05 July 2023

Application Reference No. 2023/2510/P
Proposed Development at Selkirk House, 166 High Holborn and 1 Museum Street, 10-12 Museum Street, 35-41 New Oxford Street and 16A-18 West Central Street, London WC1A 1JR
Impact on Flat 1, 3 and 5 at The Old Fire Station, 14 West Central Street, London WC1A 1JH

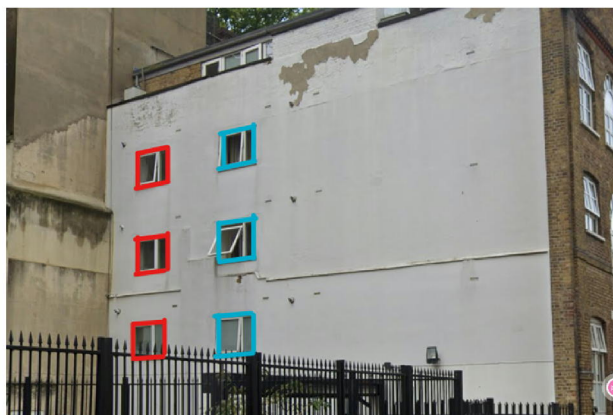
Below is an image showing the windows affected at our clients' properties. The window circled in red are the only living room/kitchen windows in these properties, and the windows circled in blue are the only windows serving bedrooms.

In terms of the impact to our client's property, the results show that the living room/kitchen window at Flat 1 would suffer a VSC ratio reduction of 40.4%, retaining a value of 7.5%. The bedroom window at Flat 1 would lose 58% of its existing VSC, retaining a value of 6.6%. We consider this to be a significant loss of daylight to these windows. The no skyline results show that both the living room/kitchen and bedroom would fall short of the BRE daylight distribution recommendations, retaining skyline visibility values of 37.2% and 58.4% respectively. The overall loss of daylight visibility in these rooms would be noticeable to the occupants and therefore, the use and enjoyment of these rooms is likely to be affected. The living room window at Flat 1 would also lose nearly half of its existing annual sunlight and would lose all of its winter sunlight.

At Flat 3, the living room/kitchen window would suffer a VSC ratio loss of 29.6% and the bedroom window would lose 46.3% of its existing VSC. These windows retain values of 10% and 9% respectively. As with the impact to Flat 1, we consider this to be a significant loss of daylight to these windows. The no skyline results demonstrate that both rooms would also fall short of the daylight distribution test, resulting in a noticeable reduction in daylight to the occupants. The windows would also suffer a significant reduction in the annual and winter sunlight hours.

With regards to Flat 5, the living room/kitchen window would pass the BRE VSC recommendations by only a small margin. The bedroom window however would lose 21.4% of its existing VSC, retaining a value of 15.8%. The bedroom at Flat 5 would breach the daylight distribution test and the living room/kitchen window would breach the test for sunlight. Whilst the impact is less significant compared with Flats 1 and 3, we consider the impact to this property to be a material planning consideration for the reasons outlined above.
